PLUG AND ABANDONMENT PROCEDURE

Valencia Canyon Unit #5

Re: Permanent Abandonment Well: Valencia Canyon Unit #5

CONDITIONS OF APPROVAL

Proposed P&A

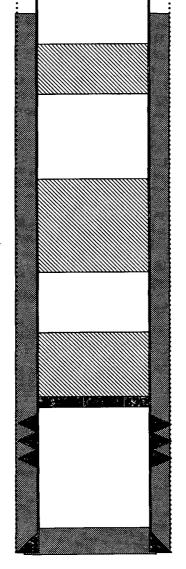
See COA Plug #3: 2180' - 2080' Class B cement, 12 sxs

See COR Plug #2: 3582' - 3310' Class B cement, 25 sxs

- 1. Plugging operations authorized are subject to the attached "General Requirements for Permanent Abandonment of Wells on Federal and Indian Lease."
- 2. Farmington Office is to be notified at least 24 hours before the plugging operations commence (505) 564-7750.
- 3. The following modifications to your plugging program are to be made:
 - a) *Set plug #2 (3851-3524) ft. to cover the Kirtland and Ojo Alamo tops. Adjust cement volume accordingly.
 - b) *Set plug #3 (2478-2378) ft. to cover the Nacimiento top.

*Plugs 1, 2 and 3 will be set inside assuming good cement isolation on backside of 4.5" production casing. Operator will run a CBL to verify cement top. Outside plugs will be required if cement top is not adequate for zonal isolation. Submit electronic copy of the log for verification to the following BLM address: tsalyers@blm.gov

Note: Plugs 1 and 2 can be combined to be set from the CR @ 4050 ft. to 3524 ft. This will be to the discretion of the operator.
